MEMORANDUM

SUBJECT: Consider Approval of New Buildings at Maple Ridge Shopping Center, 2515 White Bear Avenue

Engineering Plan Review

PROJECT: 2515 White Bear Avenue
PROJECT NO: 16-33

Original submitted site plan

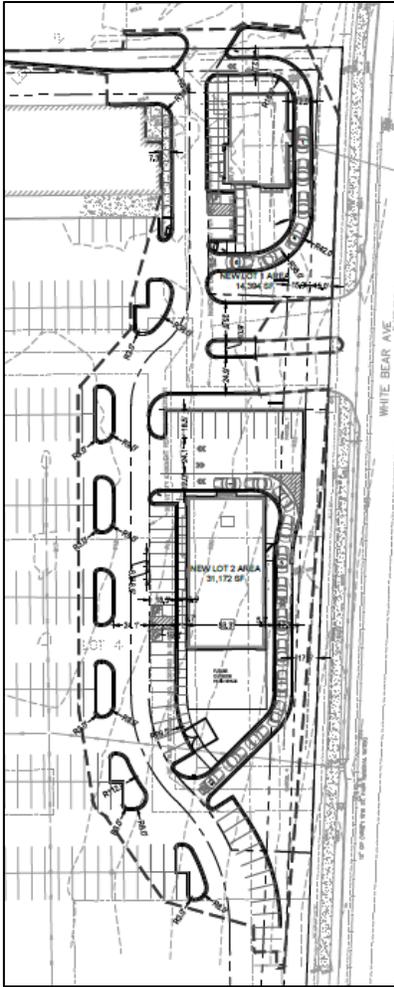
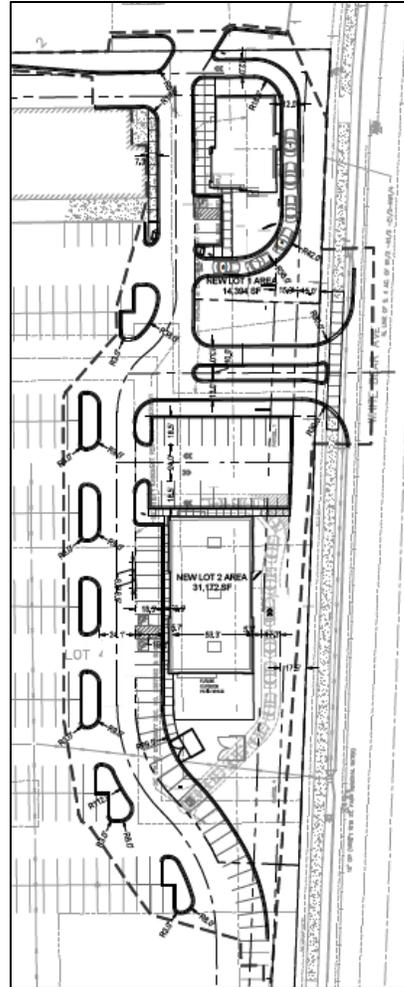
Given the CDRB's stated concerns regarding the overall site plan and parking waiver, the applicant revised its site plan to add 24 more parking spaces to the site plan. These additional 24 parking spaces, along with 72 proof-of-parking spaces, eliminates the need for a parking waiver. To add these spaces back into the site, the applicant eliminated a green space near the south building and reduced the width of the proposed drive through around the building.

"...address the concerns of the city. The most substantial change gives the north lot drive thru as much room as possible. The entry for the parking lot has been narrowed to an appropriate width to accommodate one-way traffic. This will slow cars down and relieve confusion by providing one lane for each direction of traffic. The entrance has also been shifted to the south to distance the north drive thru entrance from the parking entrance while aligning with the parking aisles."

The access off White Bear Avenue is proposed to be slimmed down which shifts the entry south of the existing entry. That additional space provides a larger buffer between the proposed building to the north and the entry access point. See the images on the next page to compare the original and revised site plans. A full sized sign plan has also been included in the agenda packet.
